Technical Bulletin

Model
911C2/C4

Subject: Radio Interference from Alternator

Number
9101

Figure 1

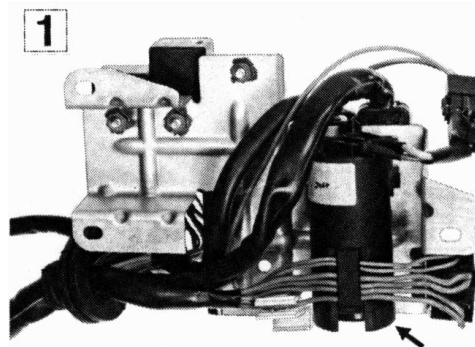
Repair Information: An interference suppression filter may be installed on the engine compartment fuse/relay board to alleviate this condition (arrow, Figure 1).

It is installed on all vehicles from production date:
November 15, 1990

Figure 2

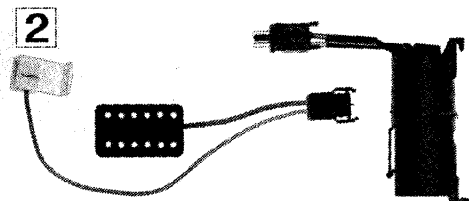
- b. Ground wire for booster.
Disconnect ground wire from booster (term.1 - brown wire) install new 4mm diameter wire and connect to ground point XX on seat cross member under the right seat.
- c. Check ignition wires for correct routing and installation. Spark plug connectors must be tight.
- d. Interference suppression filter and additional wiring harness (Figure 2) can be installed in 911 Carrera 2/4 prior to the VIN numbers on page one.

Figure 3

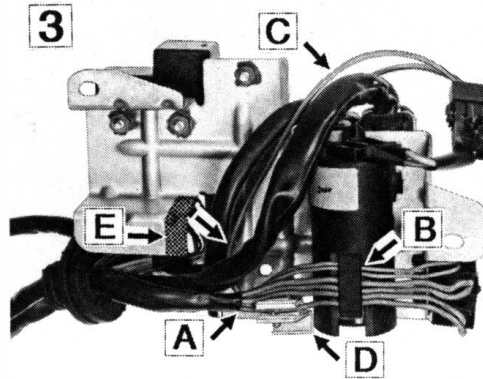
4. Cut wiring protection sleeves for wiring harness leading to fuses approximately 10cm and remove (Figure 3, arrow A).

Careful, do not cut wiring

5. Apply two layers of textile tape to edge of the carrier plate (arrow E, shaded area).
6. Install suppression filter between the two wiring plugs. Make sure suppression filter engages properly at the bottom; push against clip on filter to ease engagement. Route wiring harness leading to fuses under the engagement bracket (arrow B).
7. Connect new wiring harness (Part Number 964 645 901 00) to suppression filter 2 pin plug and 12 pin DME wiring plug.
8. Route voltage supply wire (Figure 3, arrow C) and connect with the supplied quick connector to one of the four red 2.5mm diameter wires (arrow D). The distance between the suppression filter and the quick connector must be sufficient to ease installation of the carrier plate.

Figure 4

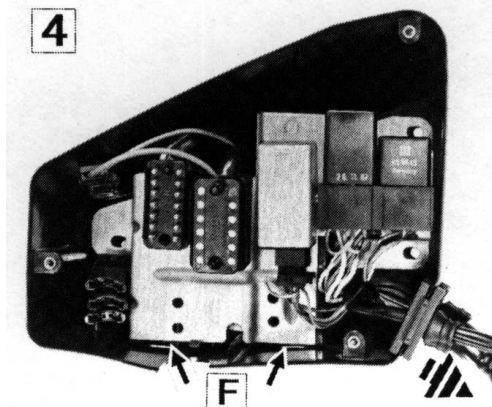
Note: When installing carrier plate, make sure the plate contacts the stops on the housing (Figure 4, arrow F). To achieve proper installation, it may be necessary to pull both wiring harnesses approximately 3cm towards the front (Figure 4) and to push bottom of suppression filter slightly towards the front.
